01/2013/0080  
Tai Clwyd 52/54 Vale Street  
Denbigh

**ITEM NO:** 1  
**WARD NO:** Denbigh Central  
**APPLICATION NO:** 01/2013/0080/ PF  
**PROPOSAL:** Demolition of existing offices and erection of a new office building, relocation of vehicular access and associated works  
**LOCATION:** 52 & 54 Vale Street Denbigh  
**APPLICANT:** Cymdeithas Tai Clwyd  
**CONSTRAINTS:** Townscape Heritage Area  
Conservation Area  
**PUBLICITY UNDERTAKEN:** Site Notice - Yes  
Press Notice - Yes  
Neighbour letters - Yes

1 GROUND PLAN  
 1:100

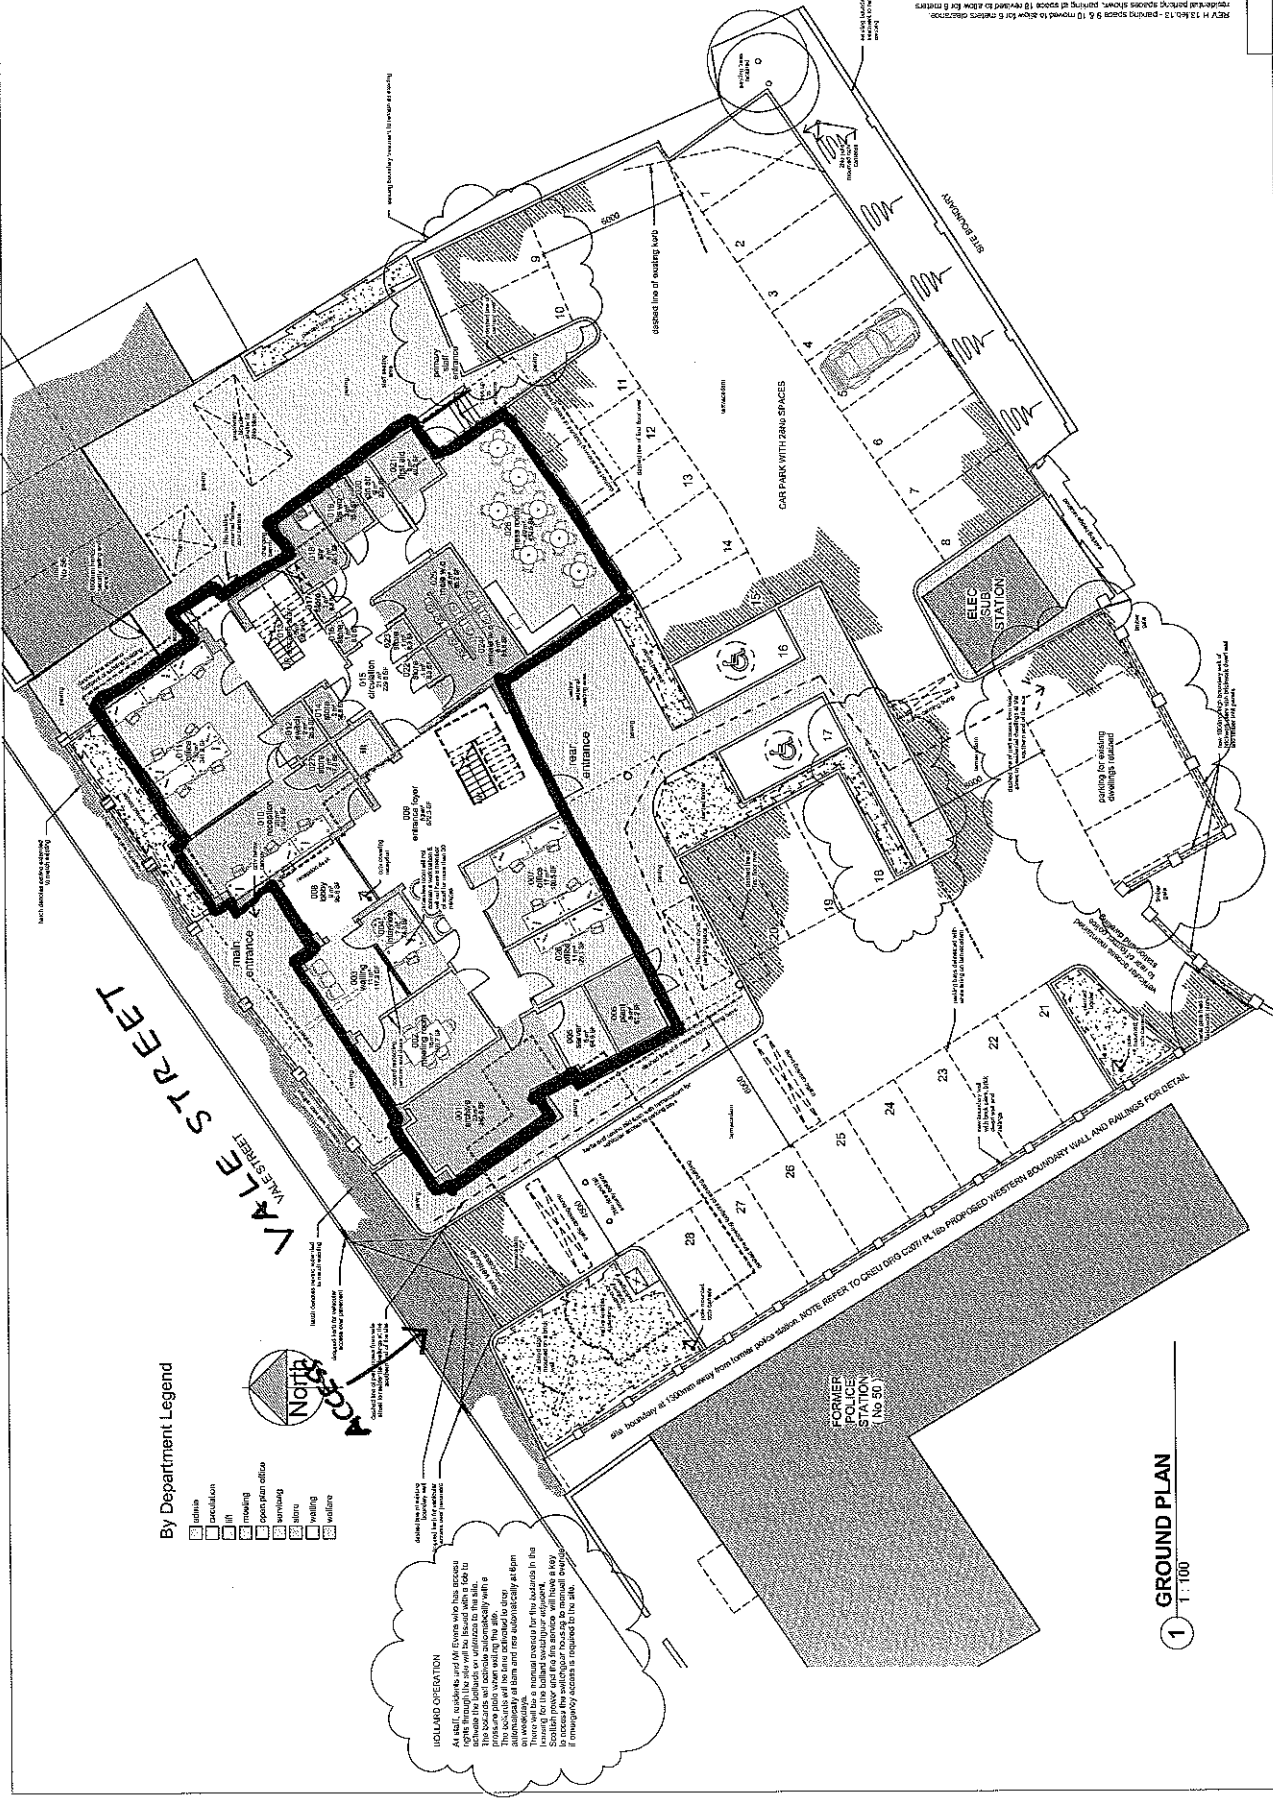
No objections, subject to inclusion of conditions requiring completion of access works before the development is brought into use.

- 1.5.1 The site plan has been amended slightly to clarify points raised by the Highways Officers.

16. Notwithstanding the submitted car parking layout details, a revised car parking layout shall be submitted to and approved by the Local Planning Authority before development commences with the approved scheme implemented before the development hereby approved is brought into use.

**1 SOUTH ELEVATION**  
1:100

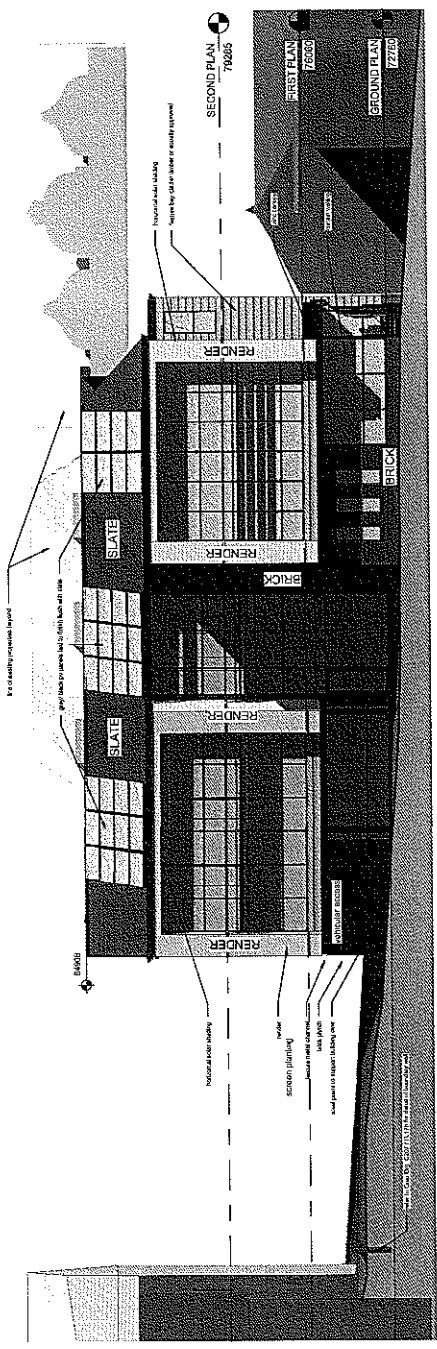
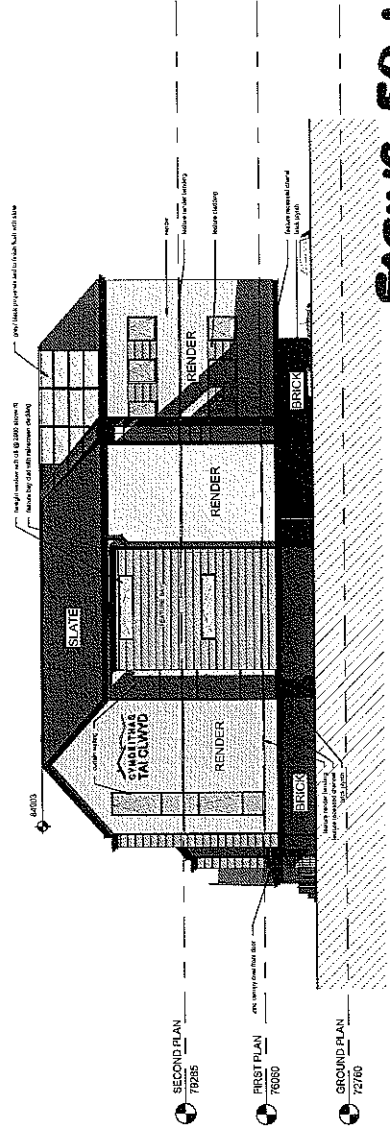
DENBIGH CIVIC SOCIETY  
Pleased to see scale has been reduced, and the line of the street is followed more closely. However concerns remain over the proprietary cladding system and its appropriateness for Vale Street.

THE GEORGIAN GROUP  
Concerns over the detail of the proposal, its impact on the historic streetscape and the setting of No. 56 Vale Street. The Georgian Group suggest that the proposal neither conserves or enhances the character of the Conservation Area and will have a harmful impact on the setting of nearby listed buildings.

Character of area, modern design is inappropriate in the Conservation Area/ overly modern design/ inappropriate use of materials and scale, amended scheme does not address previous design concerns.

- 1.1.5 The main difference between this proposal and the previously scheme is the addition of a pitched slate roof. Minor changes have also been proposed to the site plan to ensure a workable parking layout is achieved.

Prior to the commencement of the development, the written approval of the Local Planning Authority shall be obtained in respect of the walls and roof materials to be used for the development hereby permitted and no materials other than those approved shall be used.

1 EAST ELEVATION  
1:100

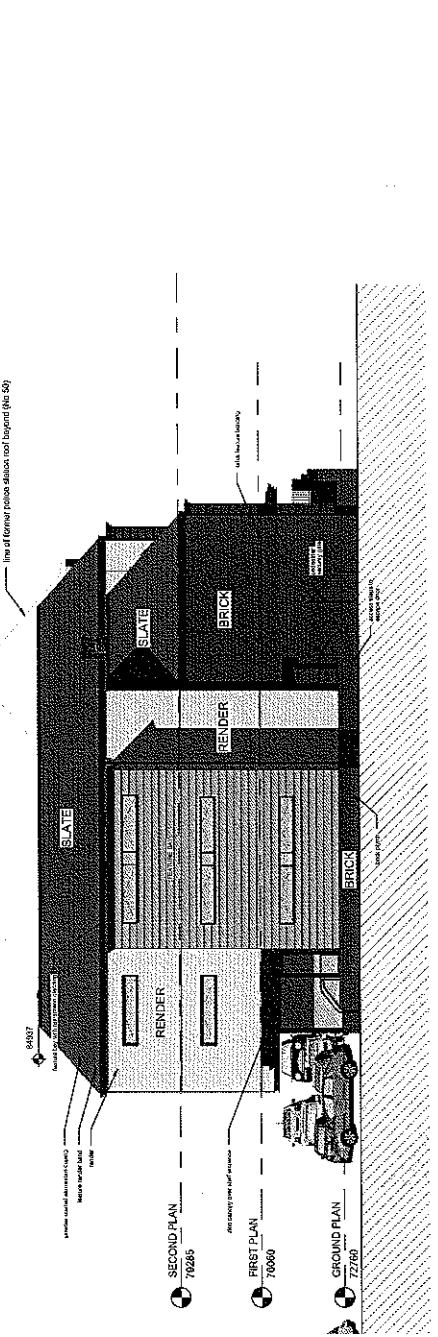
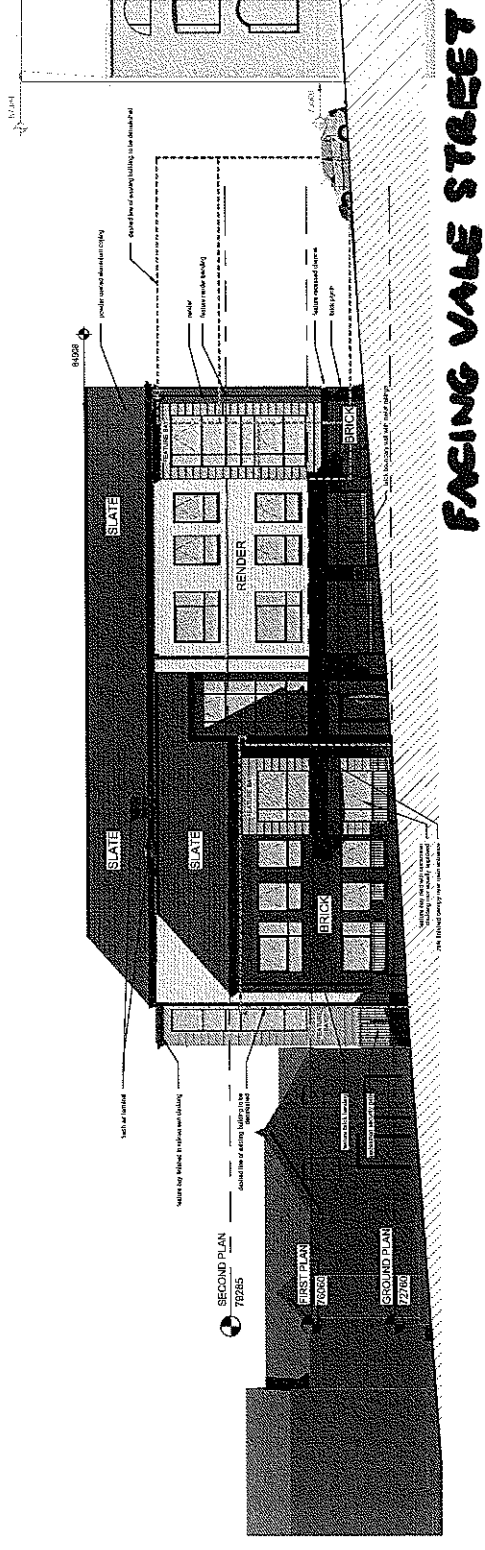
that the footprint of eastern side of the building is similar to the existing office building although the 3 storey height of the building, with the added mass of the roof is greater than the existing. There would be a minimum distance of 5.5 metres between the building and the eastern boundary with No. 58, Vale Street, and a further 8 metres to the boundary with 60, Vale Street. The western side of the building would be sited 11.5 metres from the boundary with Grove House owing to the location of the access. The proposed windows on the eastern side of the building are high level to serve stores and offices. The windows proposed on the south elevation at each level would serve offices and meeting rooms, however it is noted that there would be some horizontal solar shading on these windows as they would serve the south elevation. The rear elevation of the proposed building would be 15.5 metres from the rear boundary with the dwelling Yr Erw and the terrace of The Paddock. The relationship between the proposed office building and adjacent property has been assessed in some detail by Officers and Members. The rear gardens of Nos. 58 & 60 Vale Street have been visited by the Case Officer and by Members at the Site Panel Meetings to appreciate the respective positions of properties. Having due regard to these matters, officers suggest that as this is a historic town centre location where the pattern of development is quite mixed and close knit, the proposal would not result in significantly greater or unacceptable levels of overshadowing of adjacent residential properties or bring about unacceptable levels of overlooking, such as to warrant refusal. Whilst the addition of the slate roof will result in an overall height increase of 2.5 metres, it is to be noted that the roof would slope away from the east and west boundaries, and this is unlikely to result in a significantly greater impact on the amenity of adjacent occupiers than the previous proposal, which was not refused for amenity reasons. Officers do not consider an office use of this scale on an approach route to the town centre where there are a mix of uses would be inappropriate in this location, in respect of generating unacceptable nuisance, noise, or disturbance to occupiers of dwellings in the locality. The proposal is not considered to conflict with the residential amenity considerations of policy GEN 6.
